TECHNICAL NOTE

DATE:	24 January 2020	**CONFIDENTIALITY:**	Public
SUBJECT:	A49 VISSIM Model Review		
PROJECT:	Peel Hall	**AUTHOR:**	MJ
CHECKED:	TL	**APPROVED:**	CEW

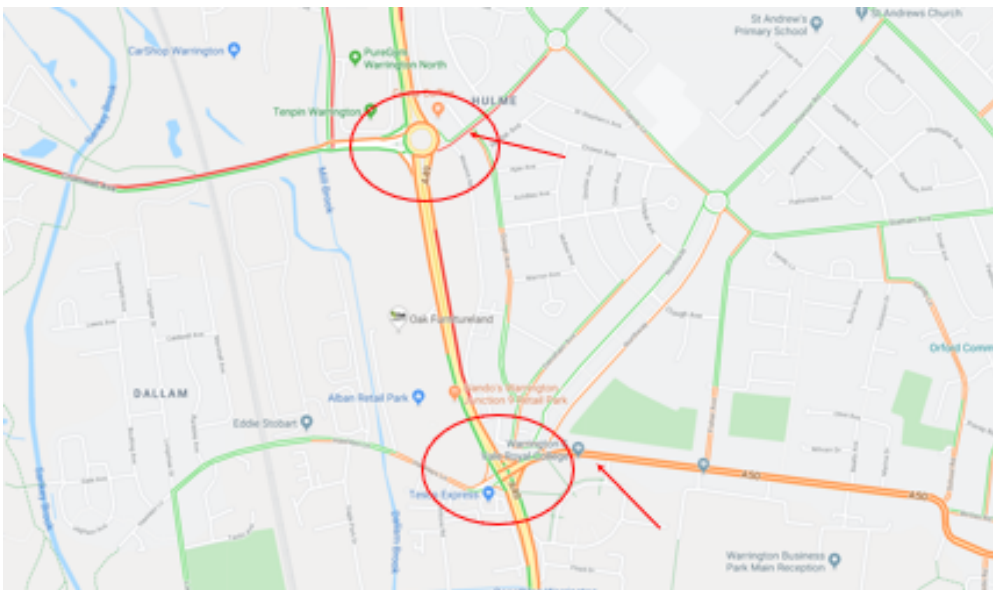
b. In both AM and PM, A49 Winwick Road/ A574 Cromwell Avenue/ Sandy Lane West Junction and A49 Winwick Road/ Nine Retail Park Junction are quite congested all through the peak times. The modelled queues are much shorter on Sandy Lane westbound and the A50 Long Lane westbound. These two roads along with M62 J9 are the main exits for vehicles generated by the proposed new development that this model will support so it is recommended to review the level of queuing and delay on these links in comparison to observed conditions because no journey time or queue comparison is currently included outside of the A49 corridor.
